2. 25-1520 12 N. FLORIDA BLANCA STREET - GATEWAY REDEVELOPMENT DISTRICT-1 - AESTHETIC REVIEW APPLICATION

12 N. Florida Blanca Street - Gateway Redevelopment District-1 - Aesthetic Review Application

From: Michael Crawford <michael@caldwellarchitects.com>
Sent: Friday, September 26, 2025 9:05 AM
To: Charles Kunze <chuck@artisansarchitecture.com>; Kevin Hagen <kevin@hhbuildinggroup.com>
Cc: Nora Bailey <norabailey52@gmail.com>; Michelle MacNeil <michellemacneil22@gmail.com>; Kelly Wiczorek <kelly.wiczorek@gmcnetwork.com>
Subject: Re: Pinto Clay Revised to comments

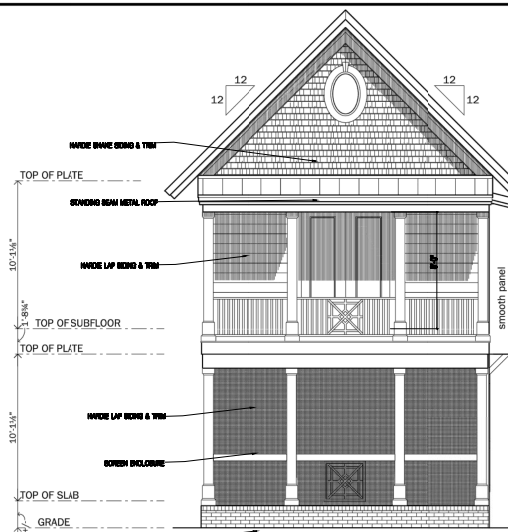
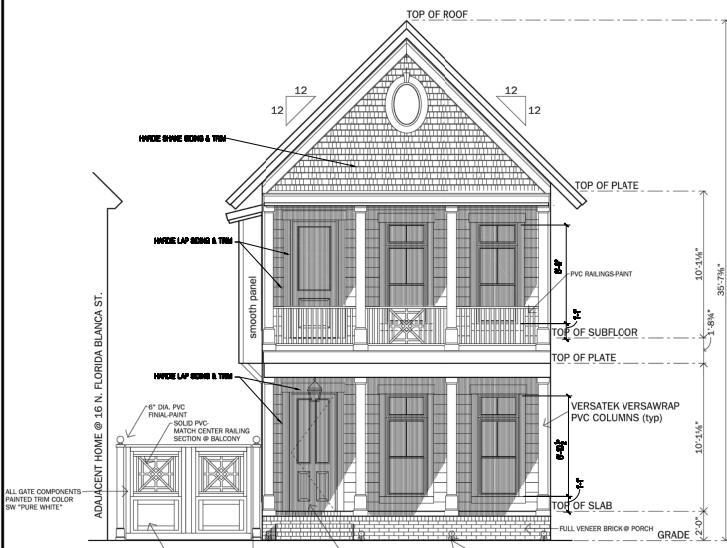
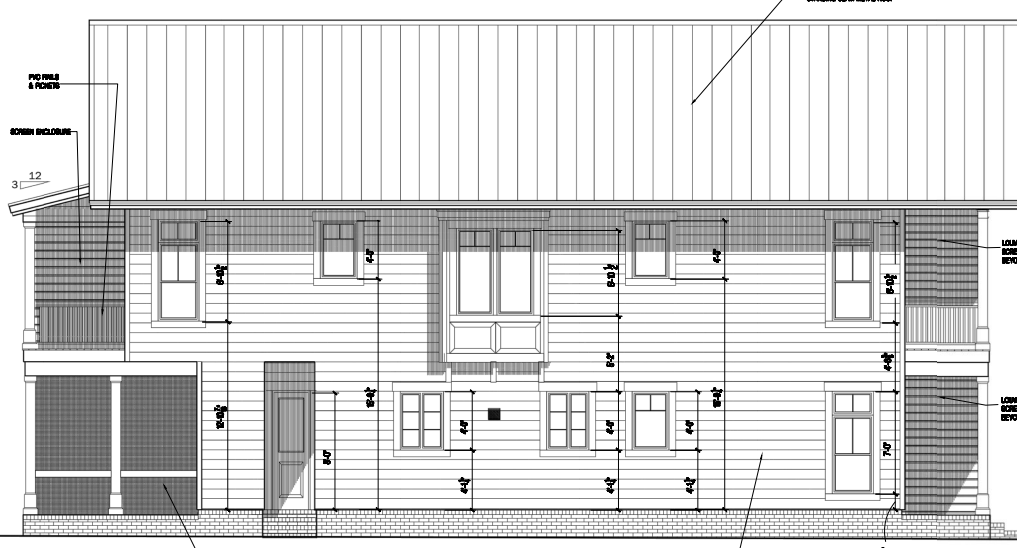
- 1. For the window grids, we understand the product sample is just that - a single sample - but we assume that your exterior elevations show the actual grid patterns that will be provided - correct? If not, please clarify.
